Energy Harbor Nuclear Corp.  
Perry Nuclear Power Plant  
10 Center Road  
P.O. Box 97  
Perry, Ohio 44081

May 18, 2021  
L-21-123

Subject:  
Perry Nuclear Power Plant  
Docket No. 50-440, License No. NPF-58  
Response to Request for Additional Information regarding a License Amendment  
Request that revises the Perry Nuclear Power Plant Emergency Plan  
(EPID No. L-2020-LLA-0282)

Response to Request for Additional Information

FIGURE 5-2 - OSC AUGMENTED RESPONSE ORGANIZATION

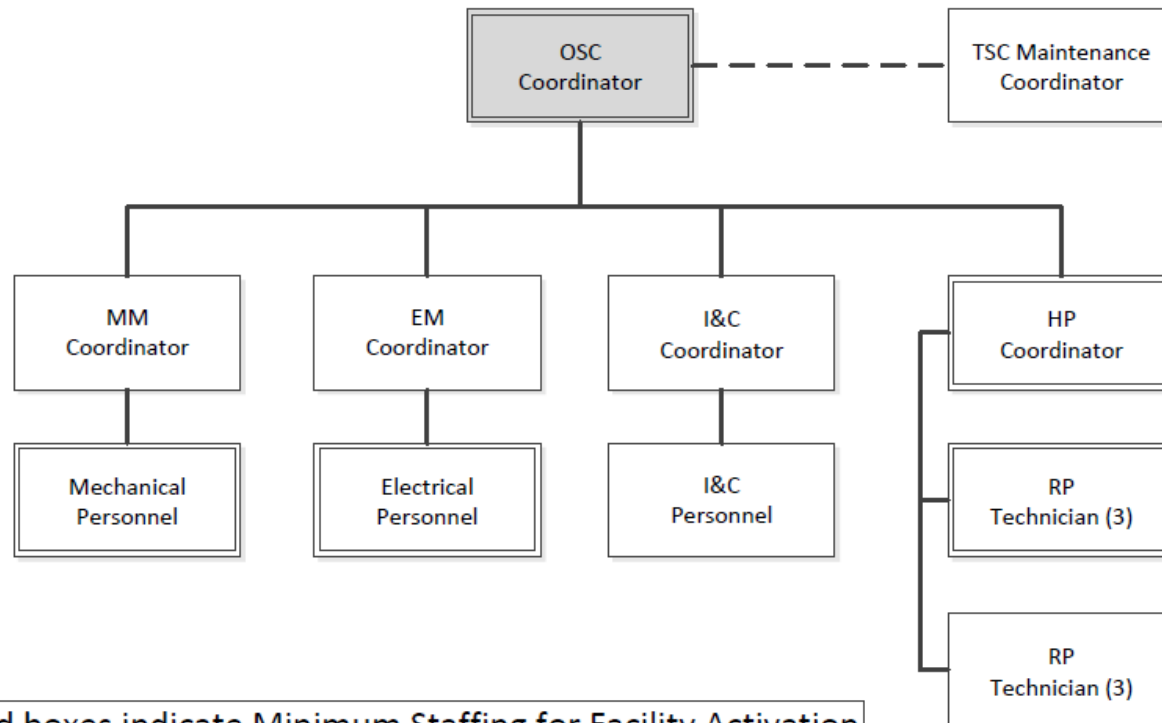
- As proposed, it does not appear to the staff that the minimum staffing as described will allow the facilities to perform their intended functions (e.g., the minimum activation staffing for the Operations Support Center is one person, the OSC Coordinator). Please provide justification that the minimum facility staffing of each facility can implement the PNPP Emergency Plan until fully staffed.

- **Describe how the functions related to repair and corrective actions will be adequately performed by the mechanical maintenance coordinator (OSC), electrical maintenance coordinator (OSC), and OSC coordinator (OSC) until relieved. Are these positions filled by personnel who maintain the same qualifications, training, and proficiency as the mechanical personnel (OSC) and electrical personnel (OSC)? Additionally, please clarify and/or correct the above statement concerning the role of the Mechanical Maintenance Coordinator Supervisor.**

The proposed changes to the PNPP Emergency Plan have been revised to reflect mechanical and electrical maintenance craft personnel arriving within 60 minutes of an Alert or higher classification to perform the initial troubleshooting and corrective actions work in the plant. In addition, the proposed changes to the PNPP Emergency Plan will reflect the mechanical maintenance coordinator and electrical maintenance coordinator positions in the OSC arriving within 90 minutes of an Alert or higher classification to provide supervisory oversight for their respective disciplines. The OSC coordinator position will direct repair and assessment personnel until the respective discipline supervisors arrive. These changes are incorporated in the clean pages of the proposed plan provided in attachments 2 and 3.

- Shaded boxes indicate Minimum Staffing for Facility Activation
- Double lined boxes indicate 60 minute responders
- Single lined boxes indicate 90 minute responders
- Dotted lines indicate positions in other facilities
